NLR-N91099
LCR 90-14

REQUEST FOR LICENSE AMENDMENT, REVISION 2
SALEM GENERATING STATION UNITS 1 AND 2
FACILITY OPERATING LICENSE NOS. DPR-70 AND DPR-75
DOCKET NOS. 50-272 AND 50-311

REQUEST FOR AMENDMENT, REVISION 2
SALEM GENERATING STATION UNITS 1 AND 2
FACILITY OPERATING LICENSE NOS. DPR-70 AND DPR-75
DOCKET NOS. 50-272 AND 50-311
NLR-N91087

Figure 1

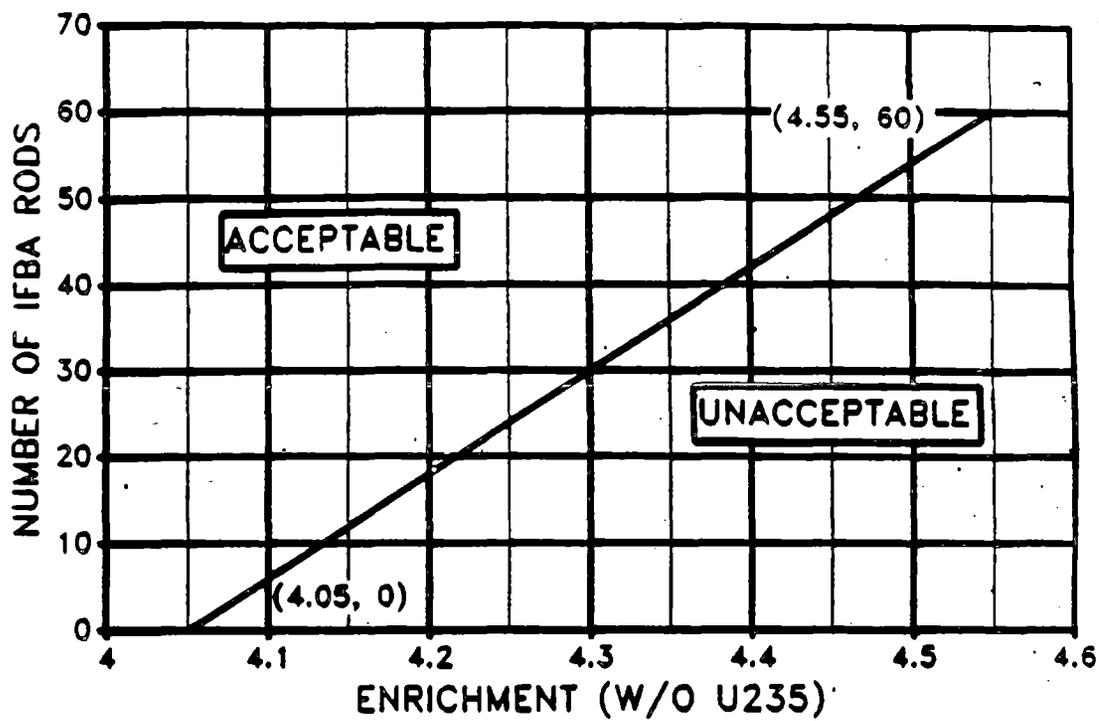
Figure 1 shows the plot of enrichment versus number of IFBA pins per fuel assembly above which the unborated fuel assembly K_{inf} is less than 1.453 at 68°F. The K_{inf} remains less than 1.453 provided at least the number of IFBA pins shown at each enrichment point on Figure 1 are loaded in symmetric patterns within the fuel assembly at the specified initial enrichment.

Figure 1 shows the constant Kinf line corresponding to the number of IFBA rods as a function of enrichment determined from this reactivity equivalencing procedure. The endpoints in the figure are 4.05 w/o U-235 with 0 IFBA and 4.55 w/o with 60 IFBA. The interpretation of the data is that the reactivity of a 4.55 w/o fuel assembly with 60 IFBA rods is equivalent to the reactivity of a 4.05 w/o assembly with 0 IFBA rods. This figure will be incorporated into section 9.1.2.1 of the Salem UFSAR.

- o The IFBA model uncertainty is evaluated to be 0.2% delta k/k for a fuel assembly containing 60 IFBA rods. This value is consistent with PSE&G studies and the result of comparing PSCPM K_{inf} values against Westinghouse generated results for the range of enrichment/IFBA combinations depicted in Figure 1.
